ENGINEERING (DRAINAGE) EVIDENCE STATEMENT

LANCEFIELD ROAD PSP &
APPLICATION FOR PLANNING PERMIT P18855

PREPARED BY ANDREW MATHESON FOR
WINCITY DEVELOPMENT PTY LTD
AUGUST 2017

Figure 1 – Earthworks Fill Batter Example

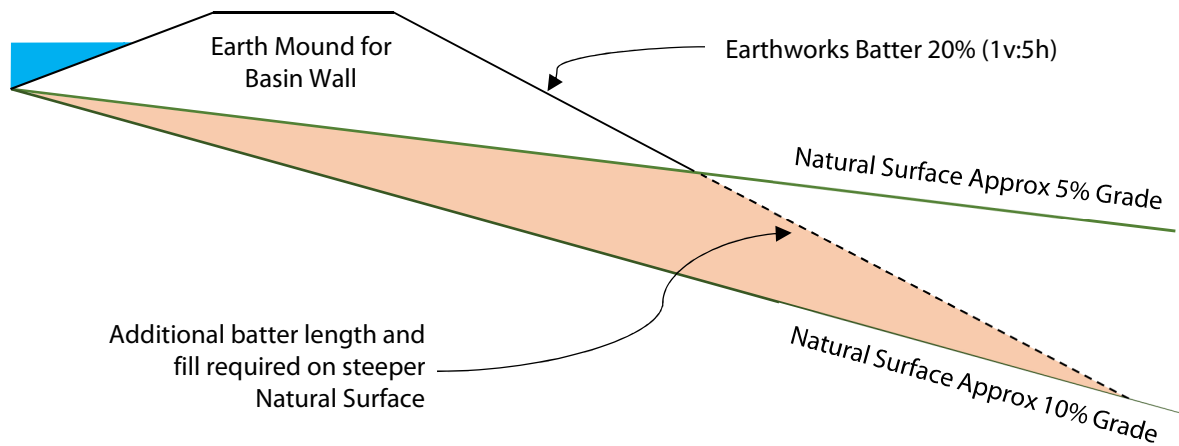
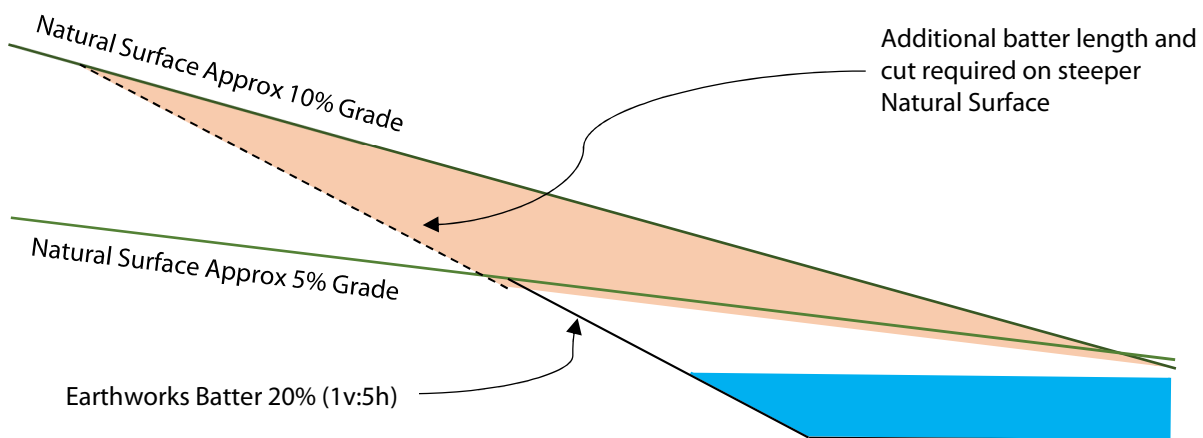
- Break of Slope Line – The placement of the wetland above the break of slope line minimises the earthworks required and thus overall footprint required for the drainage reserve. Construction of the wetland within the tributary would result in a much large infrastructure footprint and consequently disturbance to the tributary as result of batter slopes 'chasing' the existing terrain. A requirement of Melbourne Water is to achieve batter slopes no steeper than 1m vertical to every 5m horizontal (1v:5h) or 20% gradient. This results in improved safety and ability to maintain landscapes. The slope within the tributary is 1v in 5.6h or a gradient of approximately 17.8%. A 1v:5h batter slope from a 1m high embankment or dam wall would require approximately 46 metres of horizontal distance before it intersects the 1v:5.6h tributary slope. The land above the break of slope line is flatter at a slope of 1v in 18h, or a gradient of approximately 5.5%. The same scenario of a 1m high embankment of dam wall would only take approximately 7 metres of horizontal distance before it intersects the 1v:18h terrain above the break of slope line. Figures 1 & 2 below show visually the impact of earthworks construction on steep terrain.

Break of Slope Comparison Plan (3-22/PP2258)

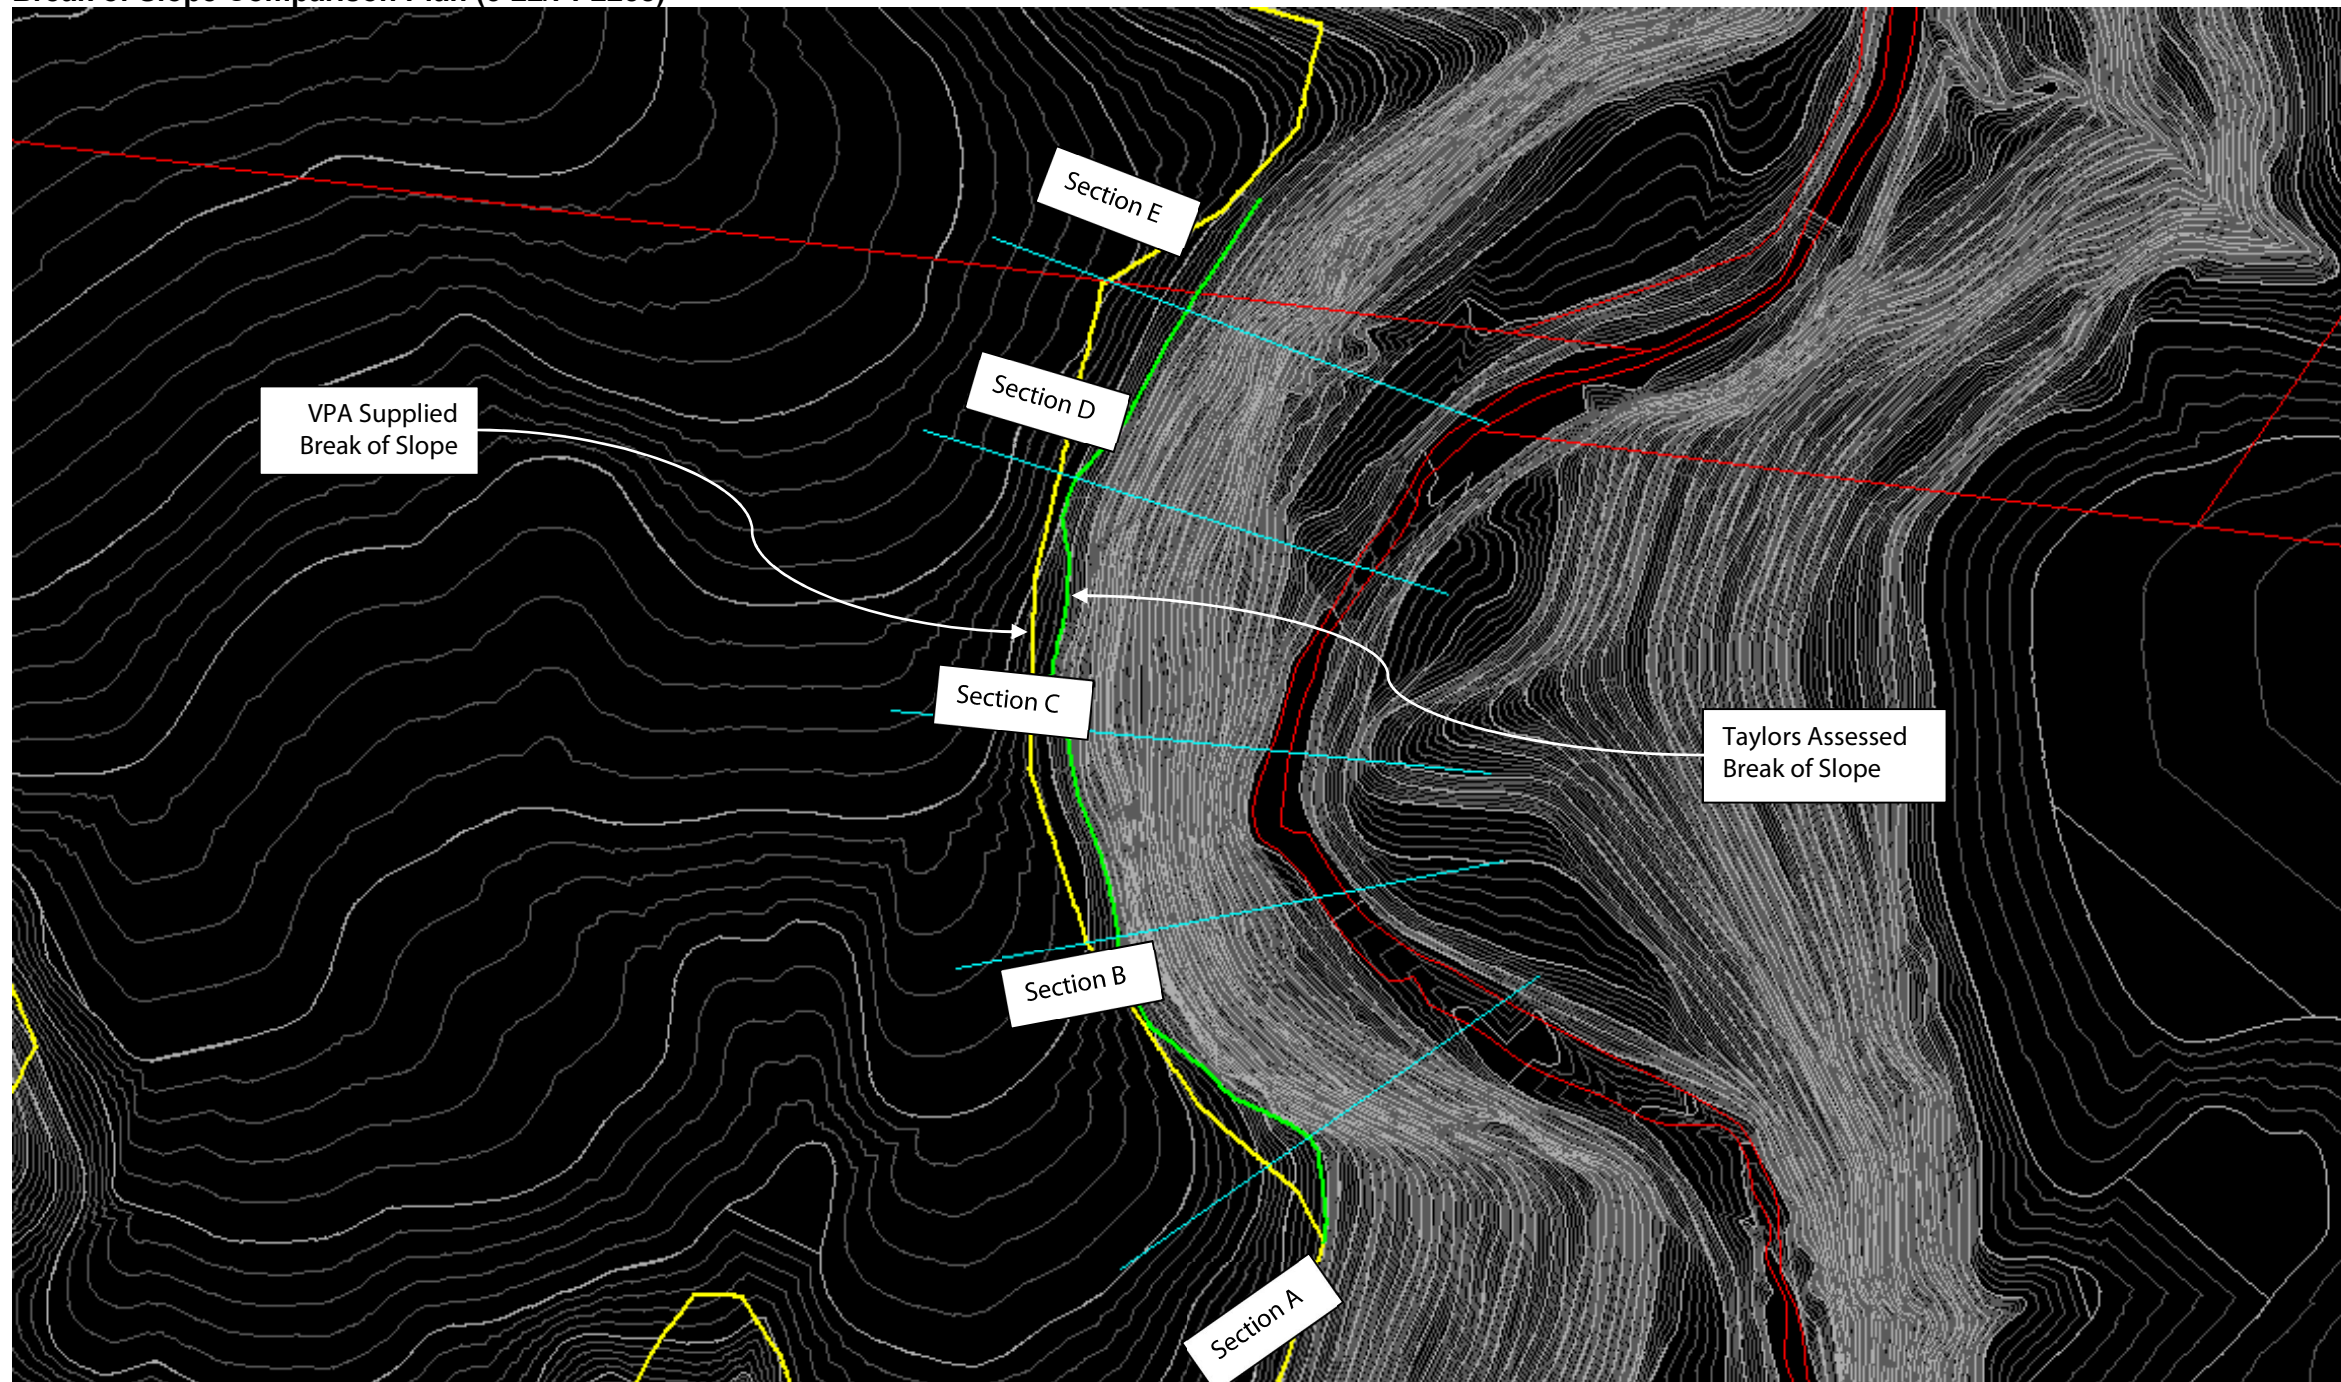
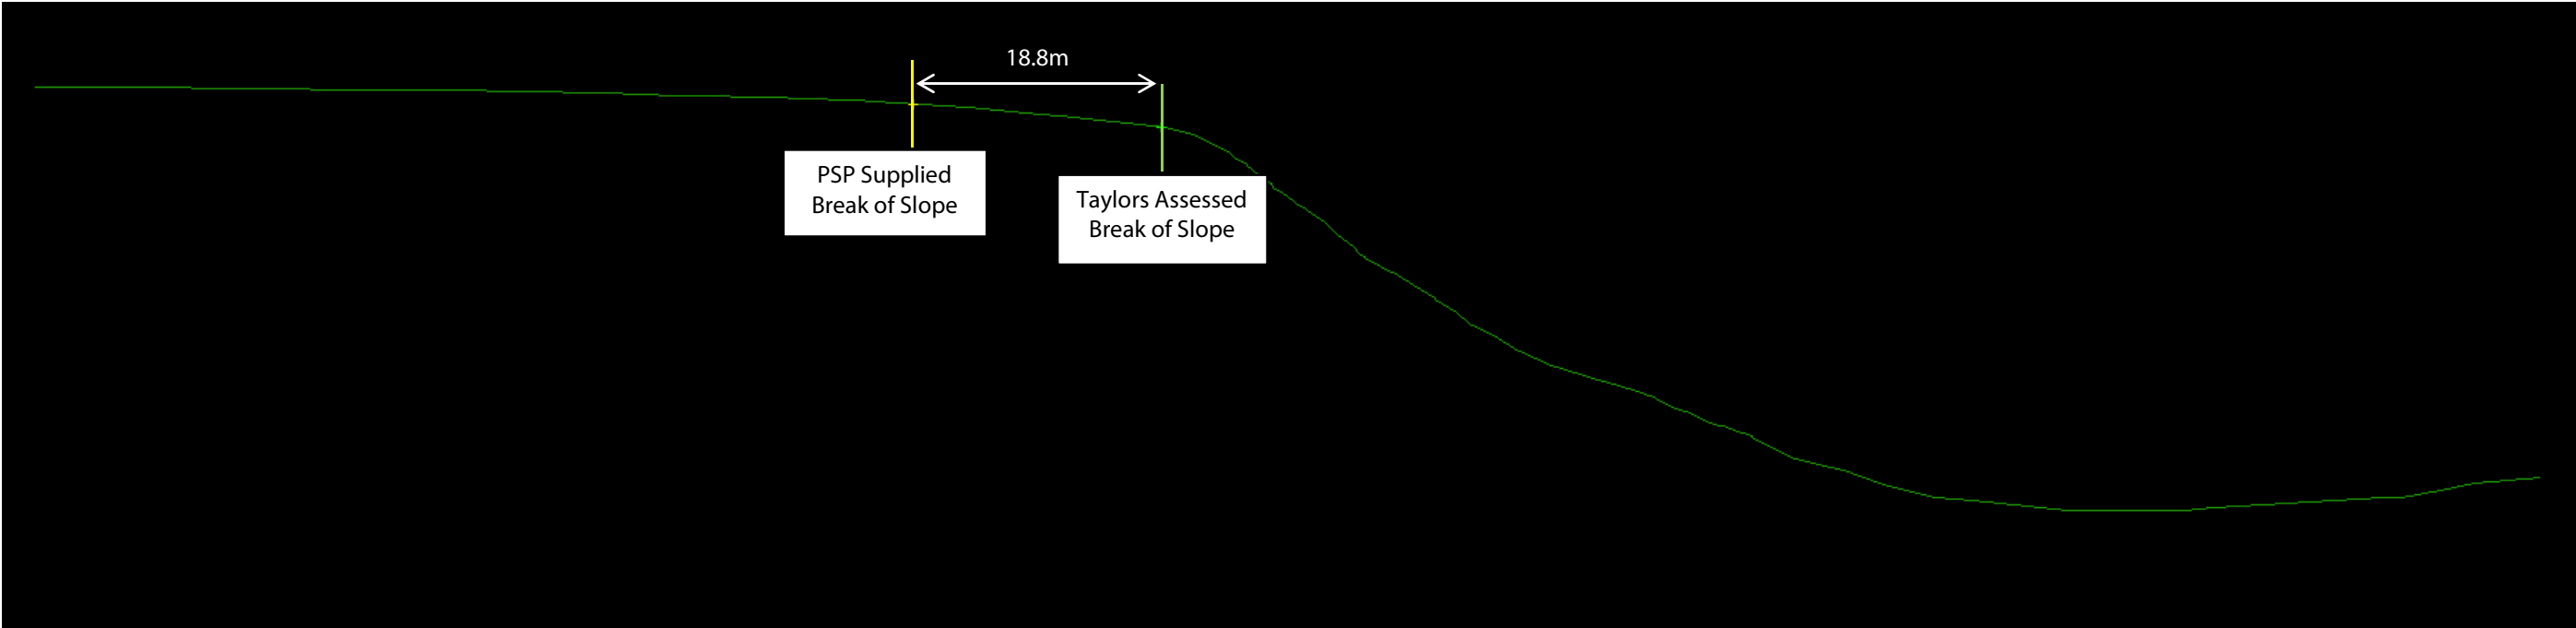
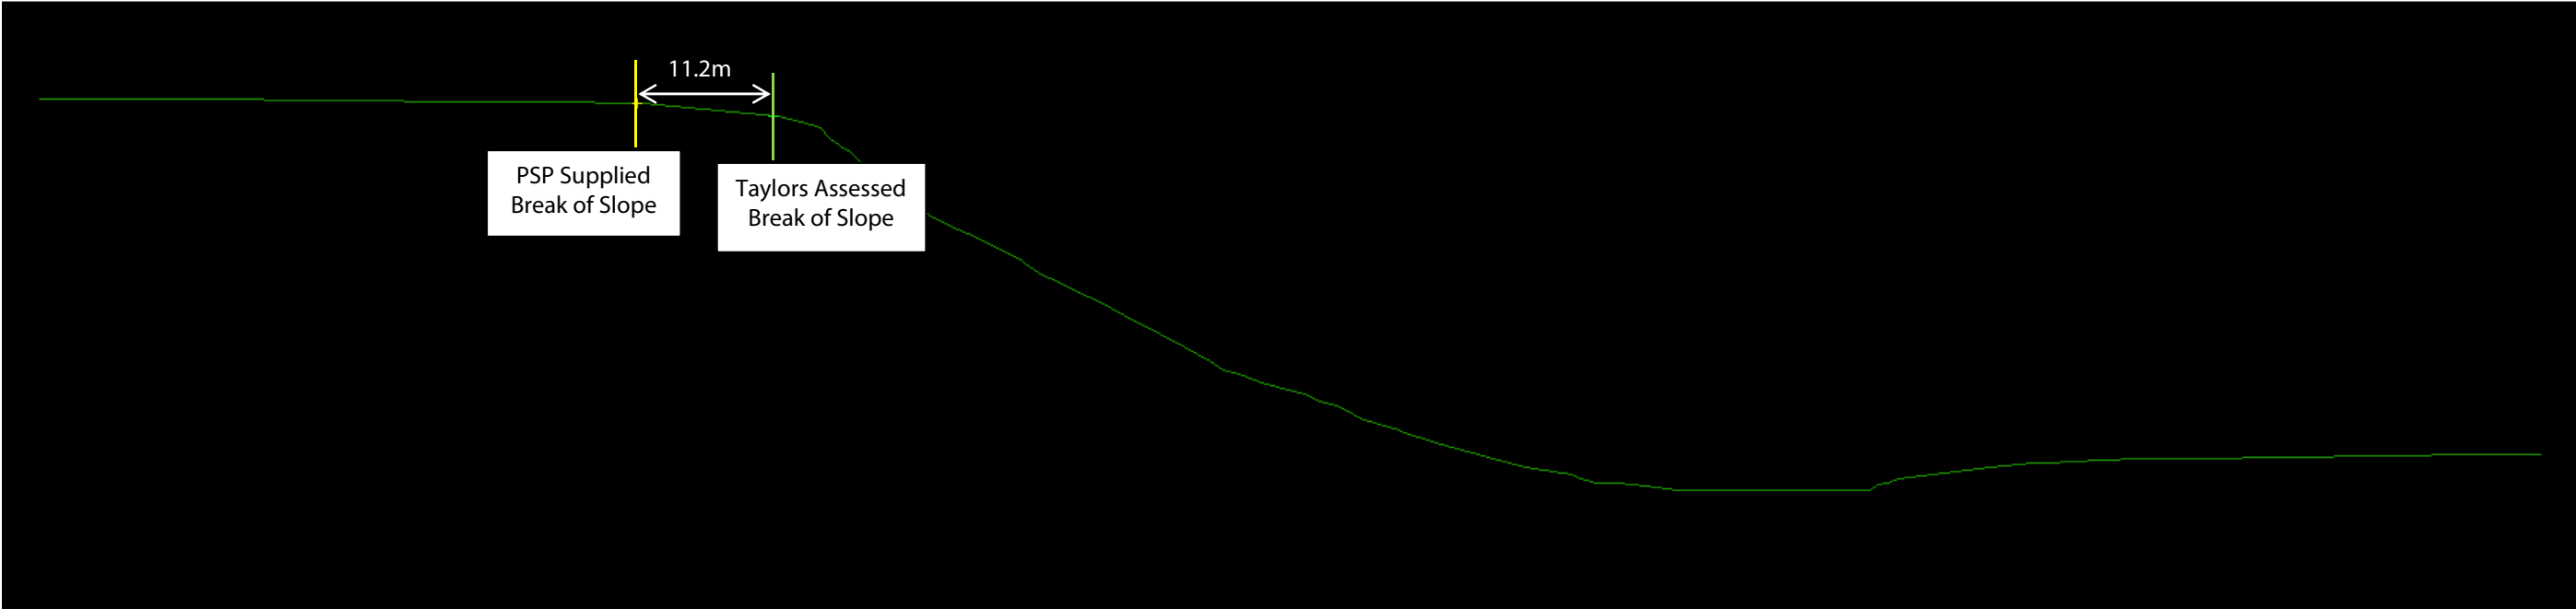
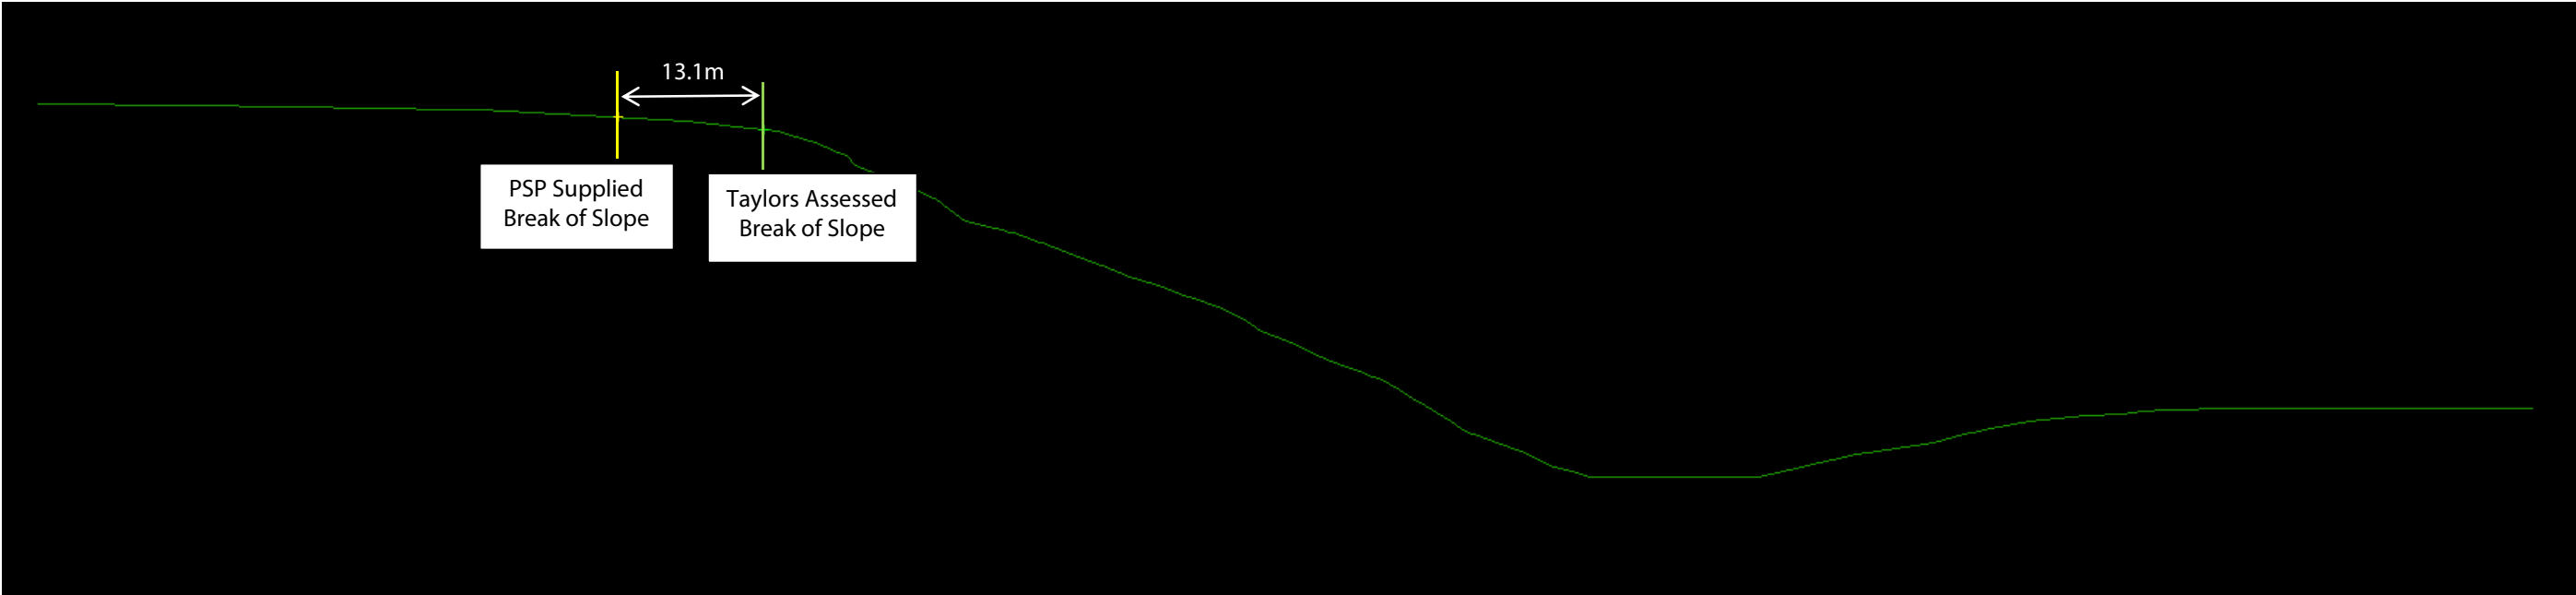
I have reviewed the revised Break of Slope line provided by the VPA and note that within the 96A Application area, the alignment has been placed satisfactorily. It is my opinion that within Title 3-22/PP2258, particularly in the north-east corner, the Break of Slope line has been incorrectly located and should be amended in accordance with scientifically assessed alignment.

WinCity have instructed me to review the break of slope line as defined by the exhibited PSP and with the revised break of slope line as provided by the VPA in May 2017. I understand that the break of slope has been defined by a 'virtual' site inspection conducted by the VPA. The exhibited PSP defines the break of slope on Plan 3 as "setback required for bush fire management, protection of visual and landscape qualities, and linear trails". The PSP also allows on the 'Local Access Street Level 1 (16m)' cross section, the development on land as steep as a 17.5% gradient. To assess the break of slope I have overlayed the supplied VPA linework on to the feature and 1 metre contour information obtained from the Victorian Government's Open Data Directory. I have examined the 1 metre contour data for abrupt changes in gradient or for areas that exceed 17.5% gradient in proximity of the VPA supplied break of slope line. It is my opinion that the VPA Break of Slope line has been incorrectly located in the north-east corner of Title 3-22/PP2258, which forms part of the Subject Land, and that the Break of Slope location which I have identified by scientific analysis should be adopted.
